Access Compliance Report Public Rights-of-Way (Curb Ramps)

Main Street: N/A Cross Street: ROSSMOOR_CENTER_WAY Location: NE

ADA ID: RPRK211208120809 Ramp Type: Type 1 - Perpendicular Initial Pass/Fail: Fail Overall Compliance: No Severity Score: 2

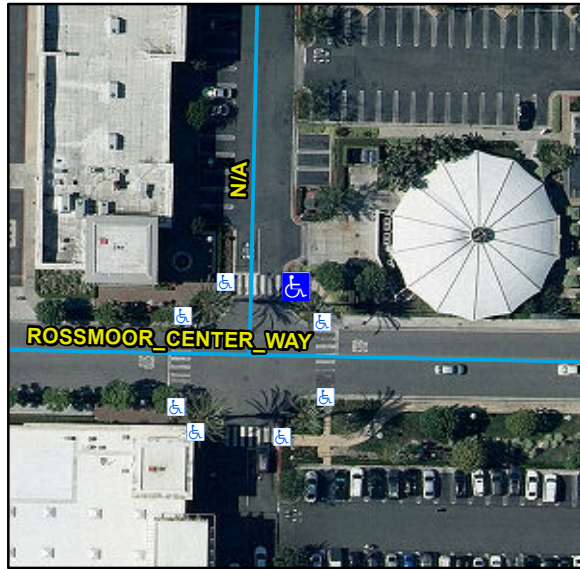
Surveyor Notes:

R304.2.2, R304.5.3, STD 1115

Possible Solutions:

Remove & Replace Entire Ramp.
